Federal Register

Friday, June 11, 2010

[Docket No. FAA-2008-0071; Directorate Identifier 2006-SW-27-AD; Amendment 39-16291; AD 2010-10-12]

Airworthiness Directives; Bell Helicopter Textron Canada Model 222, 222B, 222U, 230, and 430 Helicopters

Figure 1

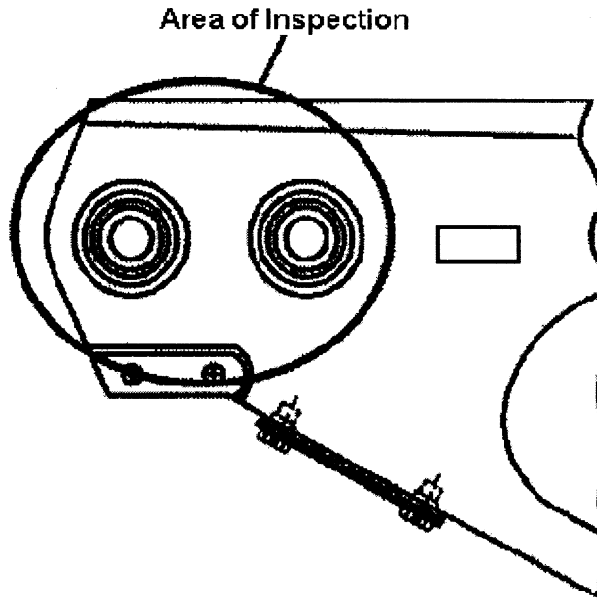
(a) Within 3 hours time-in-service (TIS), unless accomplished previously, and thereafter at intervals not to exceed 3 hours TIS, clean and visually check both sides of each blade for a crack in the paint in the areas shown in Figure

(c) Within the next 50 hours TIS, unless accomplished previously, and thereafter at intervals not to exceed 50 hours TIS, clean the blade by wiping down both surfaces of each blade in the inspection area depicted in Figure 1 of this AD using aliphatic naphtha (C-305) or detergent (C-318) or an equivalent. Using a 10X or higher power magnifying glass, visually inspect both sides of the blade in the areas depicted in Figure 1 of this AD.

(1) If a crack is found, even if only in the paint, before further flight, remove the blade from the helicopter and proceed with the following:

(2) Remove the paint on the blade down to the bare metal in the area of the suspected crack by using plastic media blasting (PMB) or a nylon web abrasive pad. Abrade the blade surface in a span-wise direction only.

(3) Using a 10X or higher power magnifying glass, inspect the blade for a crack.

(i) If a crack is found, replace the blade with an airworthy blade before further flight.

(ii) If no crack is found in the blade surface, refinish the blade by applying one coat of epoxy polyamide primer, MIL-P-23377 or MIL-P-85582, so that the primer overlaps the existing coats just beyond the abraded area. Let the area dry for 30 minutes to 1 hour. Then,

apply one sealer coat of polyurethane, MILC85285 TYI CL2, color number 27925 (semi-gloss white). Reinstall the blade.
